**METROPOLITAN GOVERNMENT OF NASHVILLE AND DAVIDSON COUNTY**

**STAFF RECOMMENDATION**  
**2000 20<sup>th</sup> Avenue South**  
**February 19, 2020**

**Application:** New Construction-Addition; Setback determination  
**District:** Belmont-Hillsboro Neighborhood Conservation Zoning Overlay  
**Council District:** 18  
**Base Zoning:** R8  
**Map and Parcel Number:** 10412014100  
**Applicant:** Matt McCrary, Allard Ward Architects  
**Project Lead:** paul.hoffman@nashville.gov

<p><b>Description of Project:</b> The current application is for a rear addition with attached garage. The façade of the addition facing the side street with garage doors is proposed at six feet, ten inches (6' 10") from the side property line, requiring a setback determination.</p>	<p><b>Attachments</b> <b>A:</b> Photographs <b>B:</b> Site Plan <b>C:</b> Elevations</p>
<p><b>Recommendation Summary:</b> Staff recommends approval of the setback determination. Staff recommends approval of the addition and attached garage with the conditions:</p>	
<ol style="list-style-type: none"><li>1. The left side of the addition or at minimum the portion housing the garage doors be moved at least ten feet (10') from the

**AS1.0**

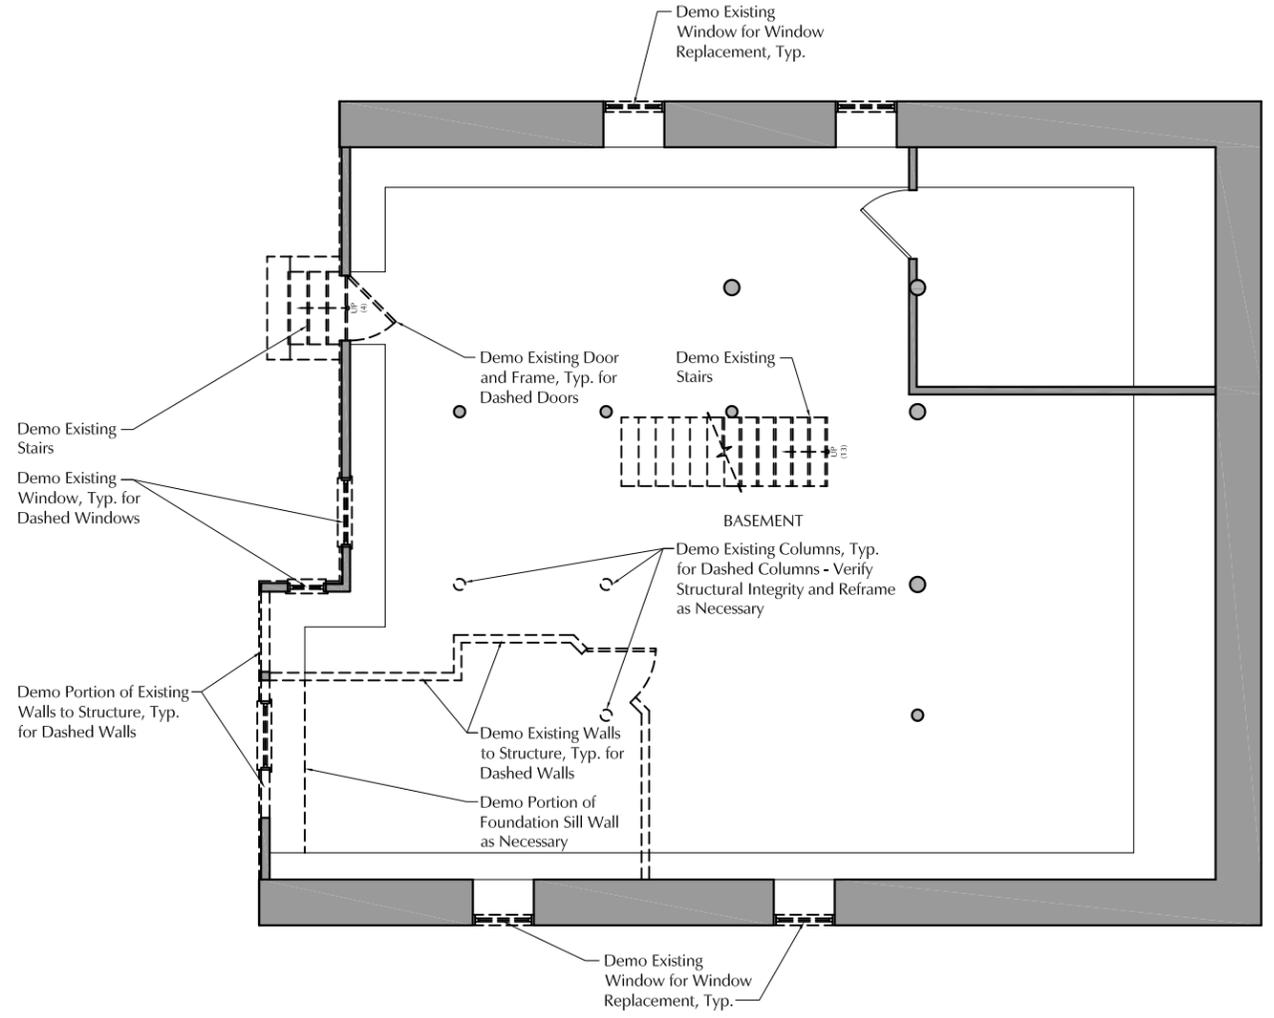
Setback: The addition will have setbacks of approximately seven feet (7') on both left and right sides. The rear wall of the addition will be approximately sixty-one feet (61') from the rear property line. The setbacks meet the base zoning requirements of five feet (5') at the sides and twenty feet (20') for the rear. However the bulk regulations of the Zoning Code (Section 17.12.030) require a structure to have twenty feet (20') street setback for local streets, which is how Portland Avenue is categorized. Section 17.20.060.D for Parking Area Design Standards also requires that garage doors opening toward a public street be a minimum of twenty feet (20') from the property line. Section 17.12.030.C.2 (Street Setbacks) allows for the street setback to be reduced by fifty percent when the rear setback of a corner lot is oriented towards the rear setback of a neighboring lot, which is the case with this lot. To comply with the Zoning Code, staff recommends the portion of the addition with garage doors facing Portland Avenue be moved approximately three feet (3') to be at least ten feet (10') away from the right-side property line. Staff recommends approval of the setback determination from twenty feet (20') to ten feet (10'). With this condition, the project will meet Section II.B.1.c for setbacks.

Outbuildings: A detached outbuilding is most appropriate historically. However, attached garages have been permitted when they are at the basement level, at the rear of the building, and in the general location of an historic outbuilding. This project meets these qualifications. With the condition that the side setback be increased, (see section on Setbacks) Staff finds that the project meets section II.B.1.i and II.B.2 of the design guidelines.

1. The left side of the addition or at a minimum the portion housing the garage doors are moved at least ten feet (10') from the left side property line;
2. Staff approve samples of brick and stone prior to purchase and installation;
3. Staff approve the color of roofing material, and final details, dimensions and materials of windows, doors and garage doors prior to purchase and installation; and,
4. If they are moved, HVAC and other utilities shall be located on the rear façade, or on the non-street-facing side of the house.

**D1.1**

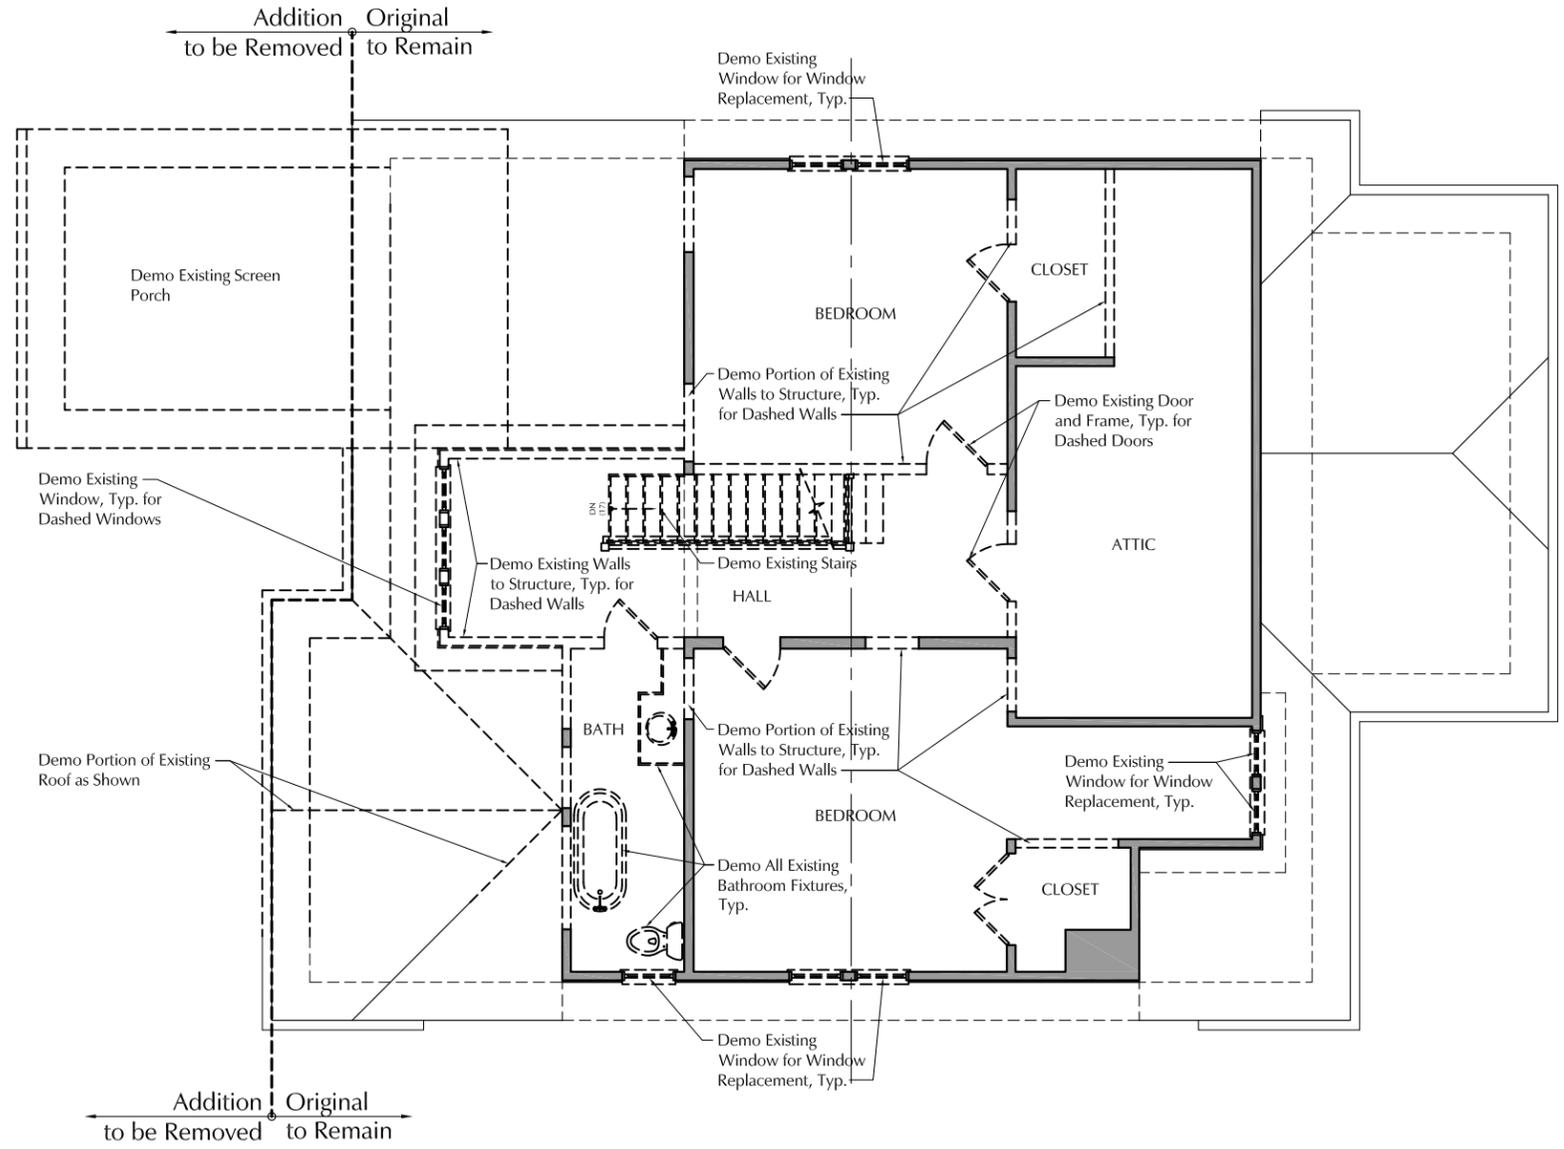
**Partial Demolition:** The application proposes removal of most the existing rear wall, a rear dormer, and a non-original rear addition and a carport (Figure 2). The carport and addition were approved and constructed in 2016.

Although the dormer and rear of the house elements are part of the original historic structure, the Commission has regularly approved the removal of them to accommodate a new addition. Therefore staff finds that the proposed partial demolition is not detrimental to the integrity of the historic house or the district, and meets section III.B.2 for appropriate demolition and does not meet section III.B.1 for inappropriate demolition.
